**PRODUCT / PROCESS CHANGE INFORMATION**

1.1 Company		STMicroelectronics International N.V
1.2 PCI No.	CRP/19/11772	
1.3 Title of PCI	Inner Box Change for Automation Packing	
1.4 Product Category	To refer to product list	
1.5 Issue date	2019-10-30

## Inner Box Change for Automation Packing

Box opening Method

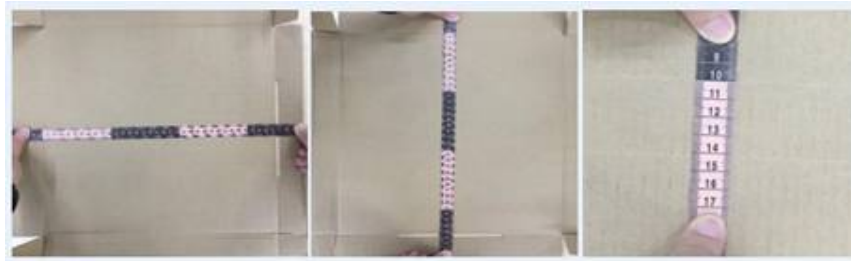
changed in Inner box for 1 " T R to accommodate Manual packing to Automated Packing (refer below for details)

C r	C A r	Remark
PN	P 1 2	P 0018	C d
Opening Method	Side opening	Top opening	C d
Inner Dimension	0x 0x 8mm	0x 0x 8 mm	N
Outer Dimension	x x 2mm	x x 2mm	N
Label	ustomi ed label on right side ulk label on left side	ustomi ed label on right side ulk label on left side	N
